## South Somerset Bridleways Association

### Response to Deadline 7

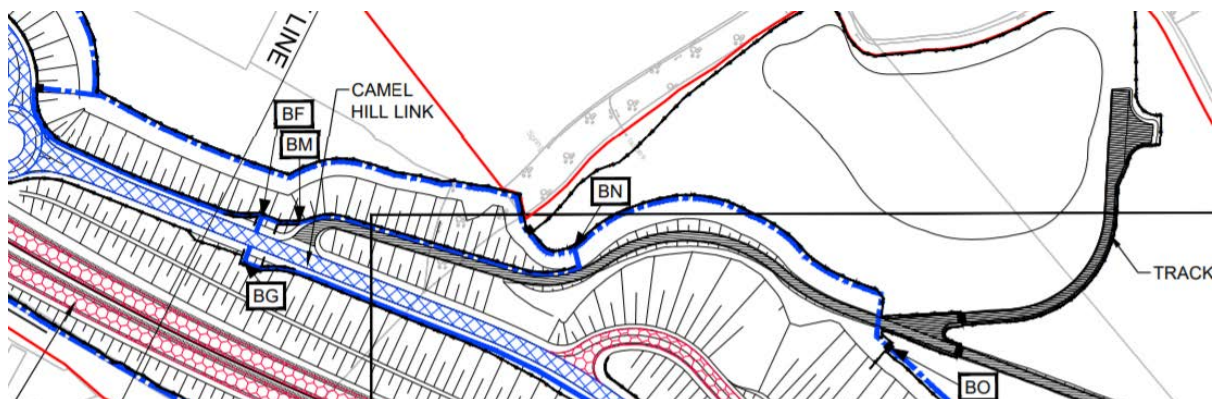
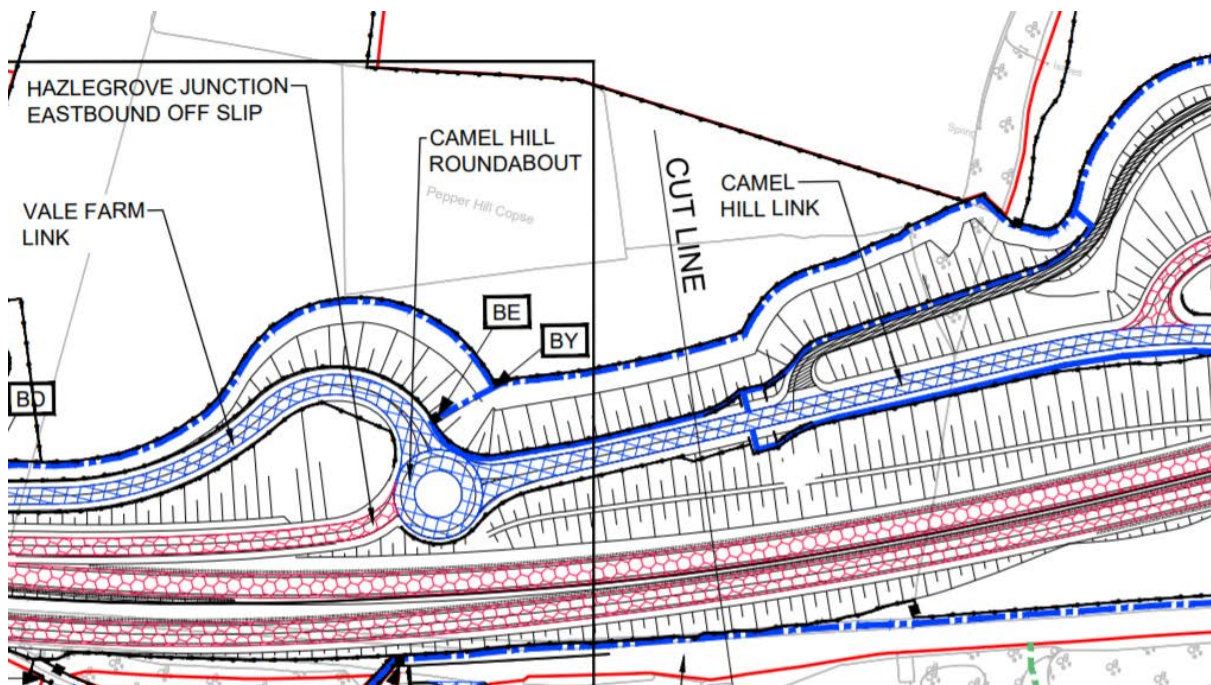
2.3.5 West Camel bridleway in verge AV – AS Although the wording says bridleway, the drawings say footway.

##### 4.2 Stear Hill, West Camel to Queen Camel

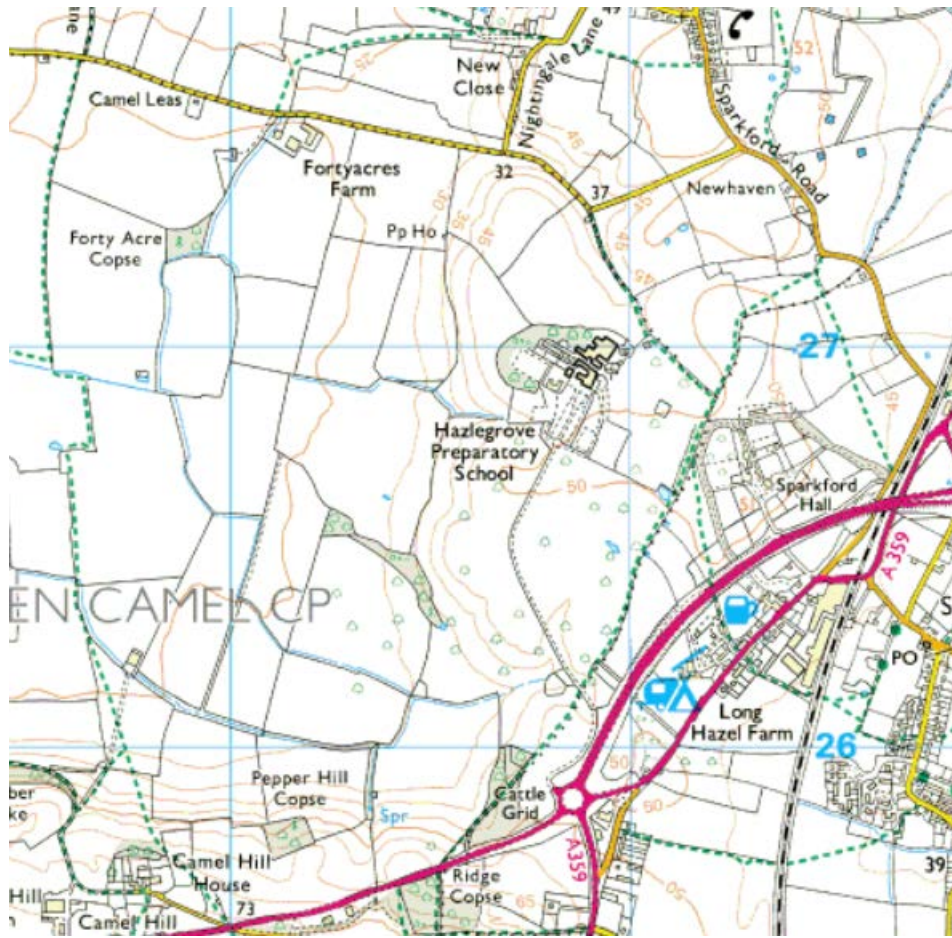
4.2.1 Either by dedicating bridleway or restricted byway rights along the construction track which is comprised of an enclosed track – and field – which are both in temporary possession without the intention to create new rights (land parcels 5/3d, 5/7a, 5/10a, 5/12a, 5/12b, 6/1a, 6/1c, 6/1d, and also 6/1e where new rights are due to be created).

4.2.2 Or, dedicate bridleway or restricted byway rights alongside the northern edge of the eastbound carriageway, which is land to be owned permanently by HE (land parcels 5/d, 5/3e, 5/2e, 5/3g, 5/3a, 5/2f, 5/3h, 5/2g, 5/3k, 5/2h, 5/3g, 7/2a, 7/4a, 7/4b, 6/1f).

#### 4.4 Queen Camel

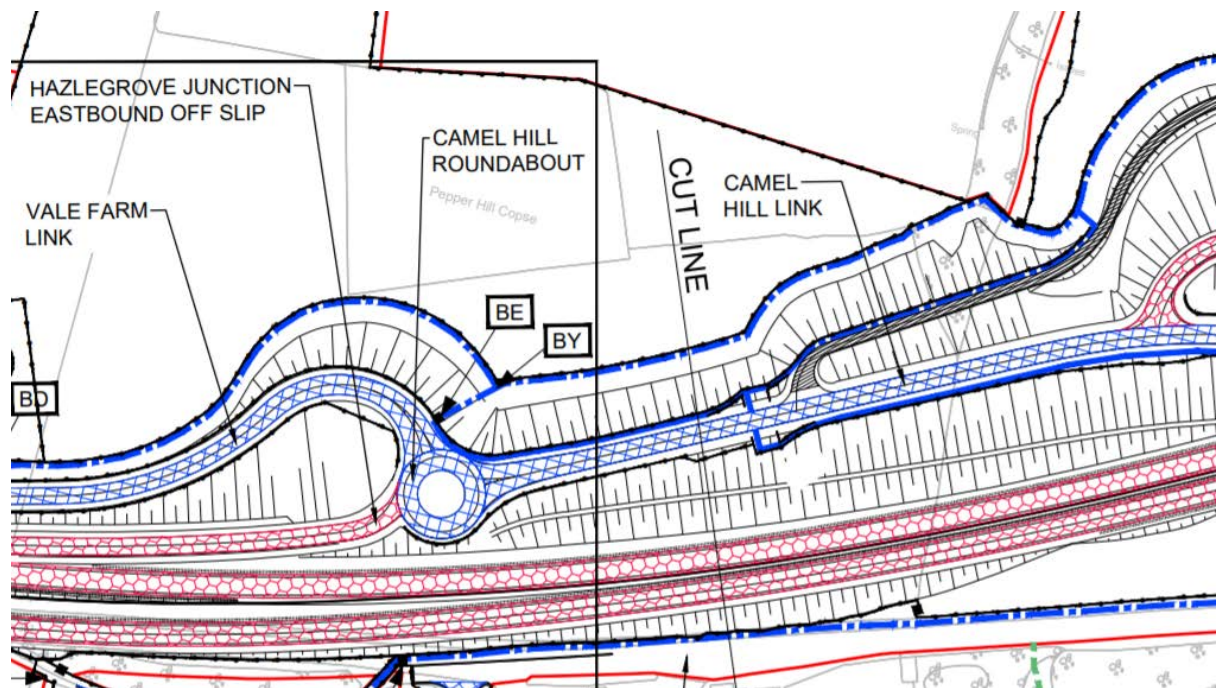
There is a proposed new right of way shown from BE to BY which links the Camel Hill roundabout with the new public bridleway at the bottom of the embankment. The gradient and drainage across it should be considered in the detailed design. Please could we have confirmation that this will be bridleway status, and the detailed design will include simple drainage run off.

#### 4.5 Old A303 westbound carriageway to Gason Lane (BK to BL) through land parcel 7/8b in Queen Camel.

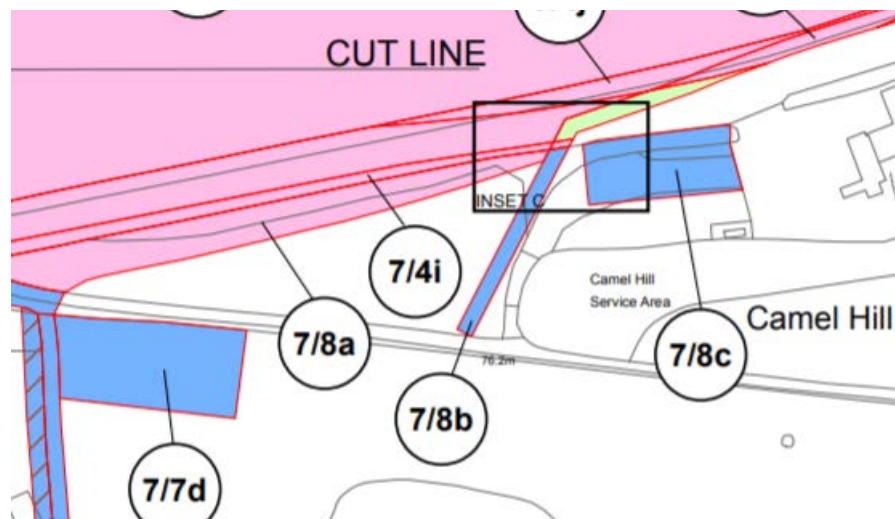
Please can HE confirm whether this will be a bridleway or restricted byway. The route leads from one minor vehicular highway to another, and so, logically, should carry restricted byway rights. Please can HE confirm that works will be done to clear the route and install a simple system of drainage run offs

#### 4.6 From north end of Gason Lane to north west end of Traits Lane, Queen Camel

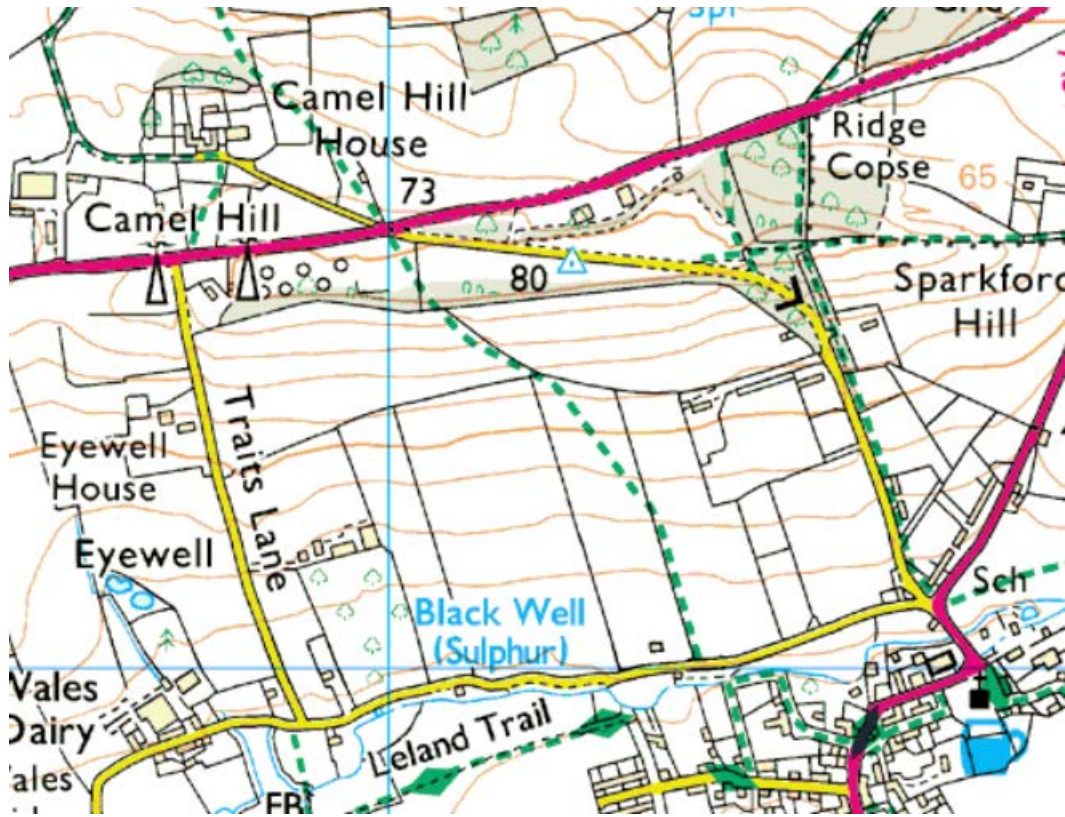
The proposed bridleway within the MOD land is a vital link in the network, and the alternatives are both too long and along lanes which cannot be recommended as they have poor sight lines and in the future are expected to carry more and heavier agricultural supply traffic when the access to the farms from the A303 is stopped up. It is still hoped that the MOD will allow horse riders, and this should be encouraged by all involved.

#### 4.7 Definitive footpath connecting local roads near Wayne's Diner

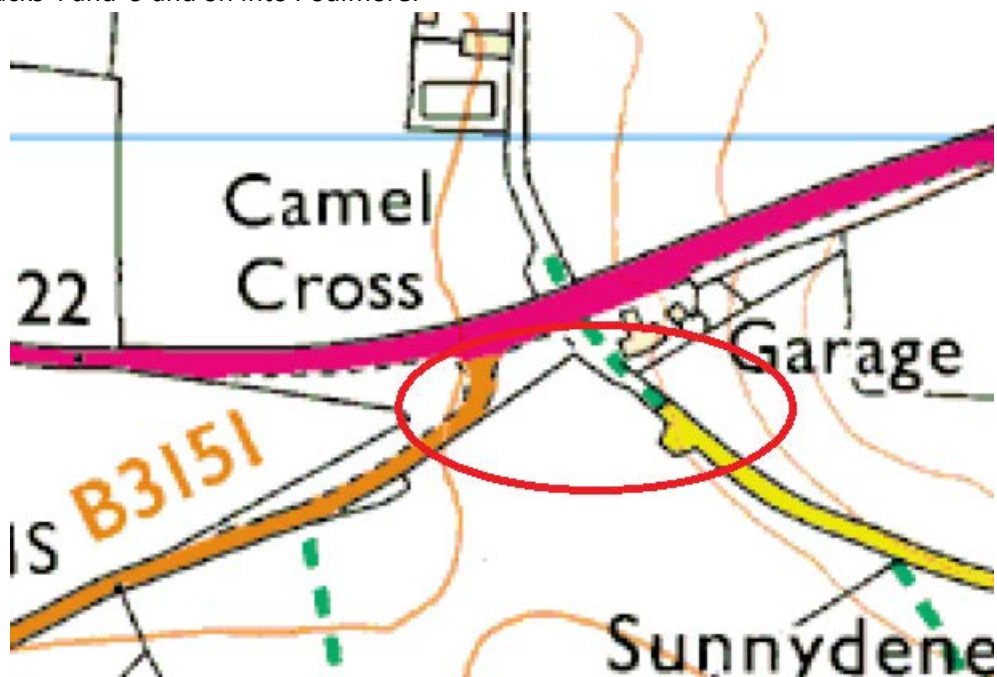
- 4.7.1 When the old A303 is de-trunked, it will become a local road at ST 5668 2487 (approximately). There is a short section of definitive footpath (Y 27/UN) which, if upgraded to restricted byway status, would allow vulnerable road users to ride from the Sunnydene Farm end of West Camel to join the route which could be provided along maintenance tracks 4 and 9 and on into Podimore.
